EDWIN I. HATCH NUCLEAR PLANT, UNIT 1

AMENDMENT TO FACILITY OPERATING LICENSE

Amendment No. 206  
License No. DPR-57

Attachment:  
Technical Specification  
Changes

Figure 3.4.9-3 (page 1 of 1)  
Pressure/Temperature Limits for Criticality

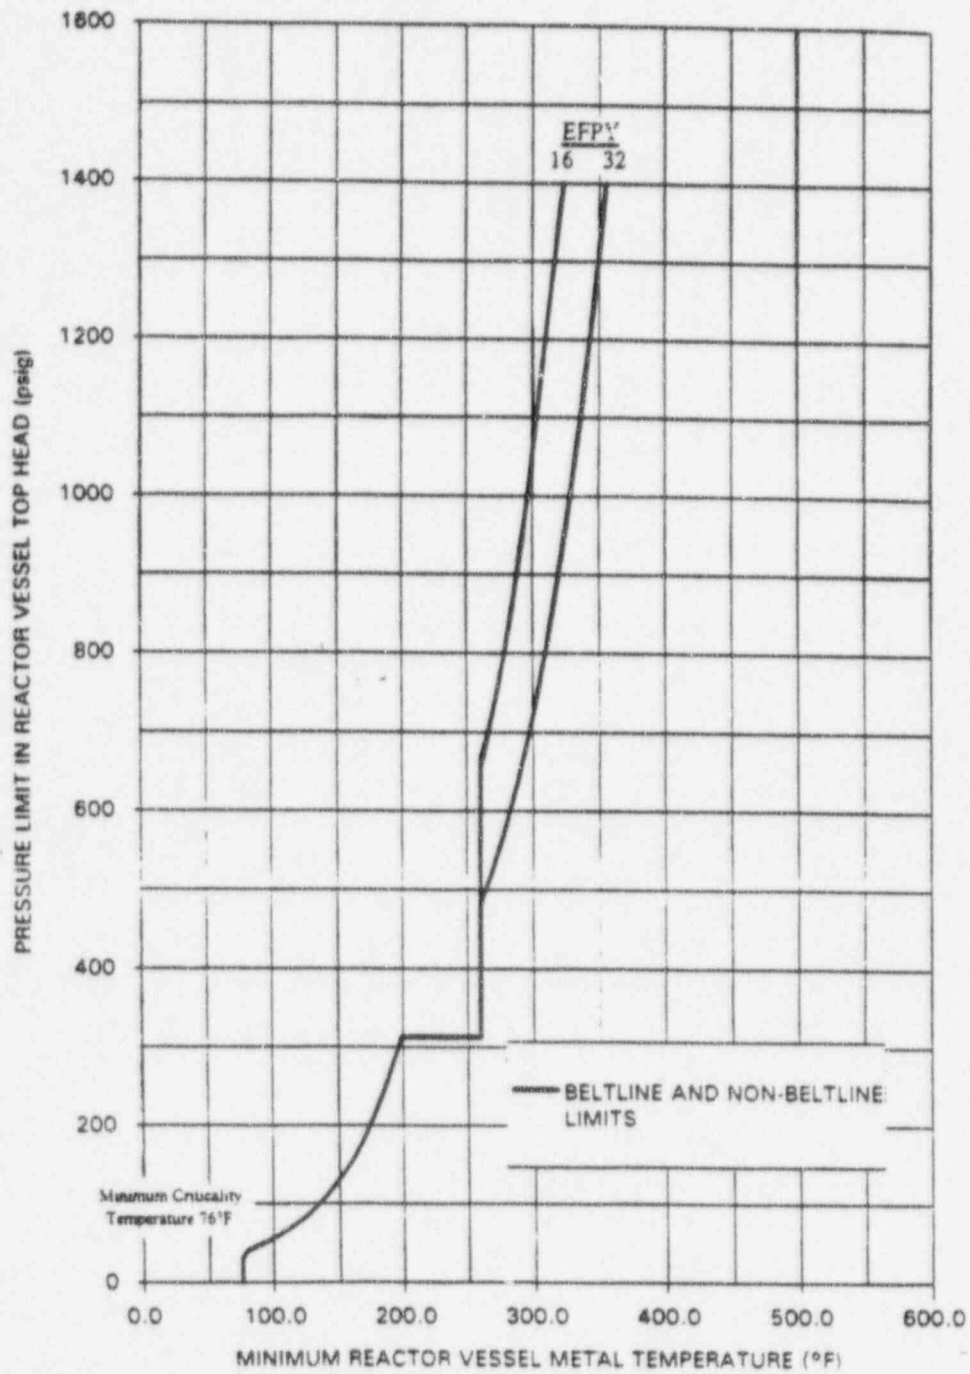
SURVEILLANCE	FREQUENCY
<p>SR 3.4.9.2 -----NOTE----- Only required to be met when the reactor is critical and immediately prior to control rod withdrawal for the purpose of achieving criticality. -----</p> <p>Verify RCS pressure and RCS temperature are within the criticality limits specified in Figure 3.4.9-3.</p>	<p>Once within 15 minutes prior to initial control rod withdrawal for the purpose of achieving criticality</p>
<p>SR 3.4.9.3 -----NOTE----- Only required to be met in MODES 1, 2, 3, and 4 during startup of a recirculation pump. -----</p> <p>Verify the difference between the bottom head coolant temperature and the reactor pressure vessel (RPV) coolant temperature is <math>\leq 145^{\circ}\text{F}</math>.</p>	<p>Once within 15 minutes prior to starting an idle recirculation pump</p>
<p>SR 3.4.9.4 -----NOTE----- Only required to be met in MODES 1, 2, 3, and 4 during startup of a recirculation pump. -----</p> <p>Verify the difference between the reactor coolant temperature in the recirculation loop to be started and the RPV coolant temperature is <math>\leq 50^{\circ}\text{F}</math>.</p>	<p>Once within 15 minutes prior to starting an idle recirculation pump</p>

Figure 3.4.9-1 (page 1 of 1)  
Pressure/Temperature Limits for  
Inservice Hydrostatic and Inservice Leakage Tests

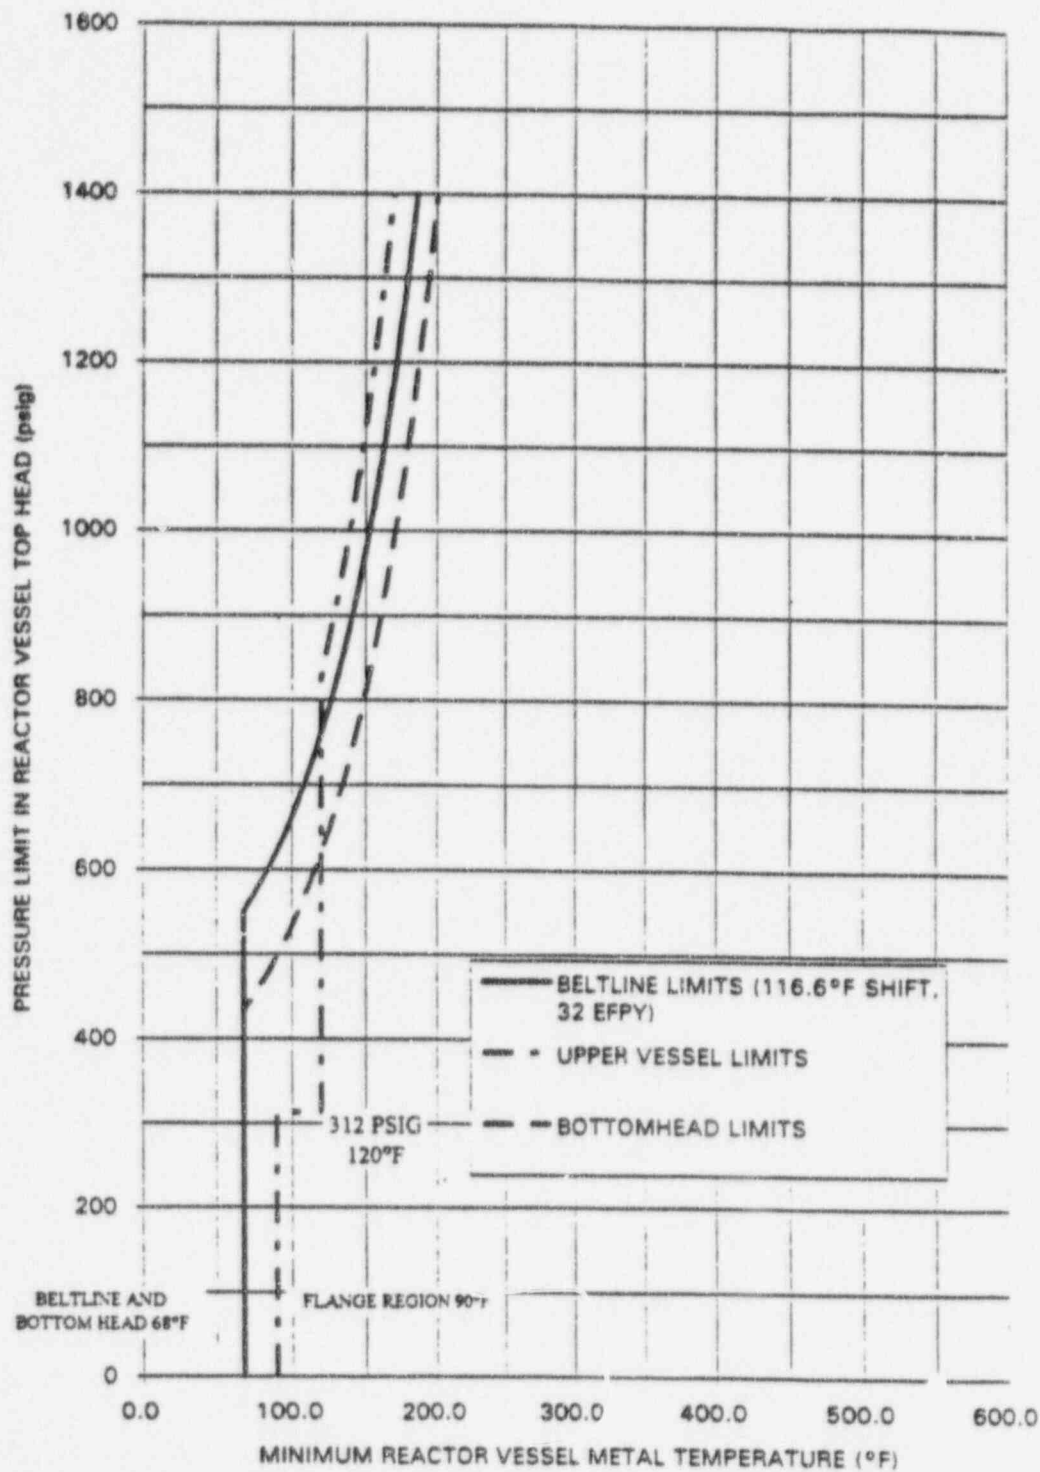
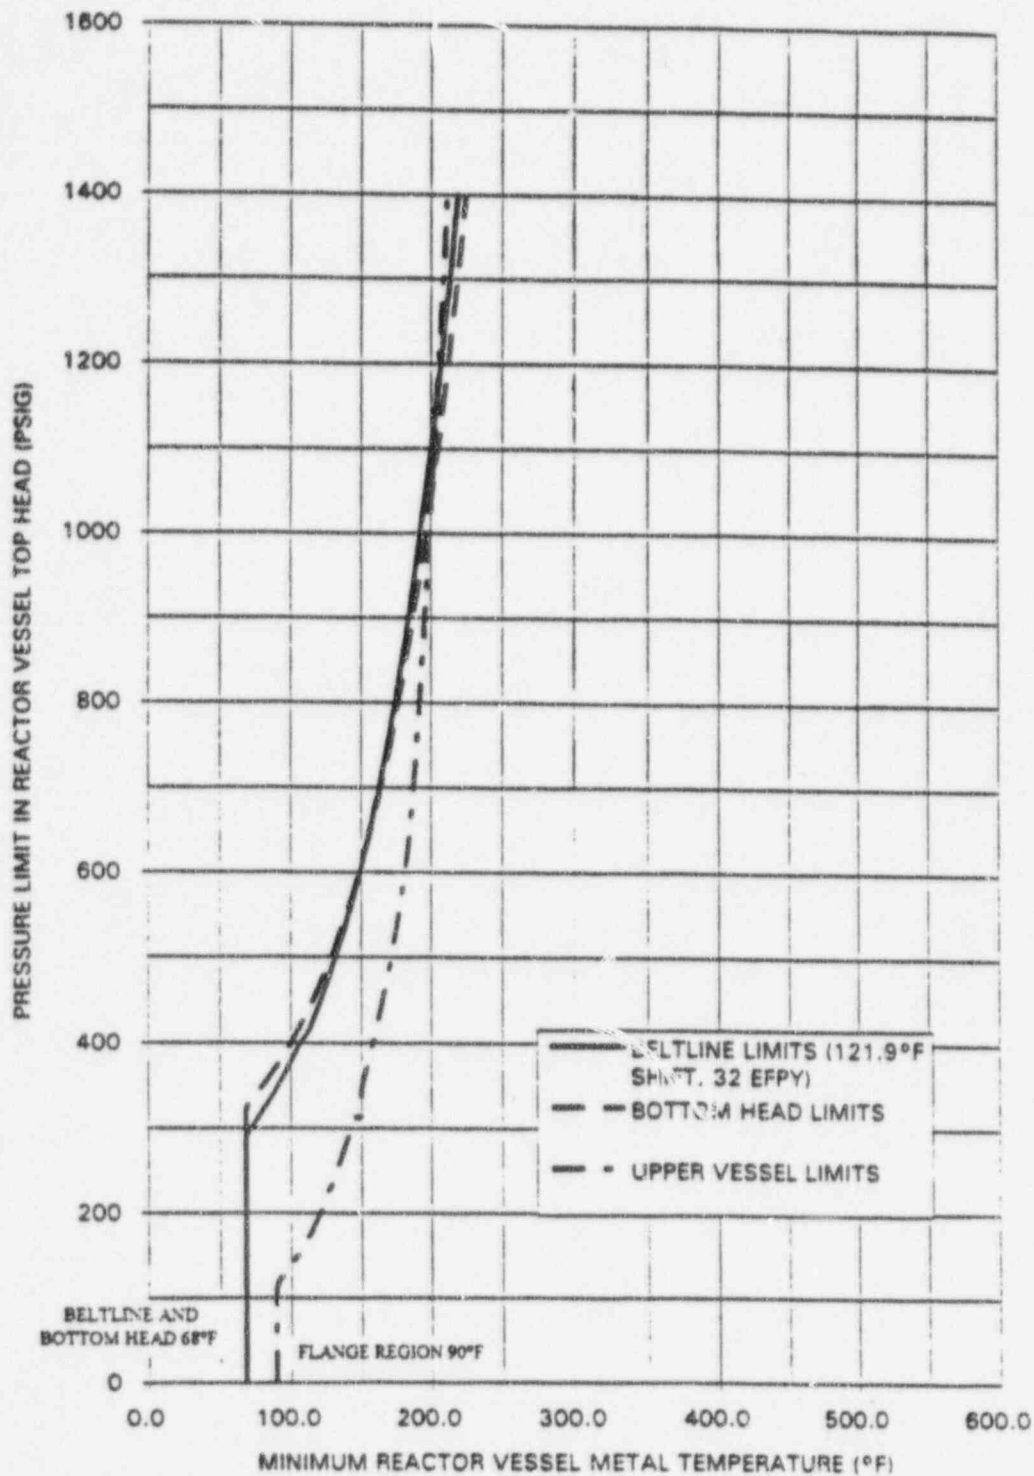
SURVEILLANCE	FREQUENCY
<p>SR 3.4.9.1    Verify:</p> <ul style="list-style-type: none"> <li>a.    RCS pressure and RCS temperature are within the limits specified in Figures 3.4.9-1 and 3.4.9-2 during RCS inservice leak and hydrostatic testing, and during RCS non-nuclear heatup and cooldown operations; and</li> <li>b.    RCS heatup and cooldown rates are <math>\leq 100^{\circ}\text{F}</math> in any 1 hour period during RCS heatup and cooldown operations, and RCS inservice leak and hydrostatic testing.</li> </ul>	<p>30 minutes</p>

Figure 3.4.9-3 (page 1 of 1)  
Pressure/Temperature Limits for Criticality

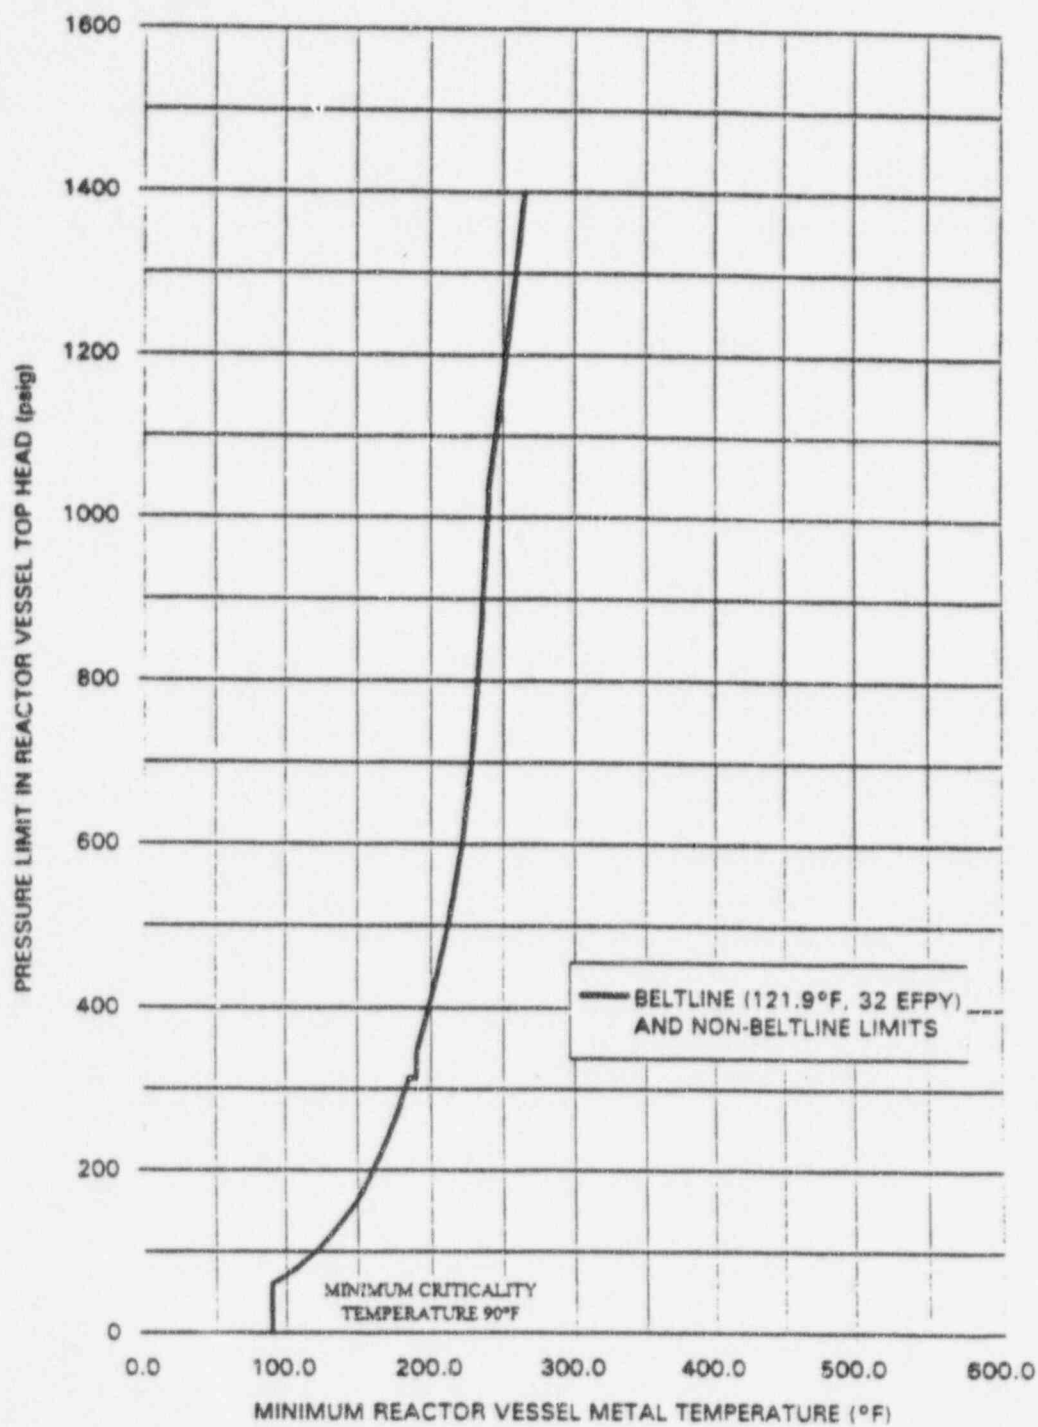
SURVEILLANCE	FREQUENCY
<p>SR 3.4.9.2 -----NOTE----- Only required to be met when the reactor is critical and immediately prior to control rod withdrawal for the purpose of achieving criticality.</p> <p>Verify RCS pressure and RCS temperature are within the criticality limits specified in Figure 3.4.9-3.</p>	<p>Once within 15 minutes prior to initial control rod withdrawal for the purpose of achieving criticality</p>
<p>SR 3.4.9.3 -----NOTE----- Only required to be met in MODES 1, 2, 3, and 4 during startup of a recirculation pump.</p> <p>Verify the difference between the bottom head coolant temperature and the reactor pressure vessel (RPV) coolant temperature is <math>\leq 145^{\circ}\text{F}</math>.</p>	<p>Once within 15 minutes prior to starting an idle recirculation pump</p>
<p>SR 3.4.9.4 -----NOTE----- Only required to be met in MODES 1, 2, 3, and 4 during startup of a recirculation pump.</p> <p>Verify the difference between the reactor coolant temperature in the recirculation loop to be started and the RPV coolant temperature is <math>\leq 50^{\circ}\text{F}</math>.</p>	<p>Once within 15 minutes prior to starting an idle recirculation pump</p>
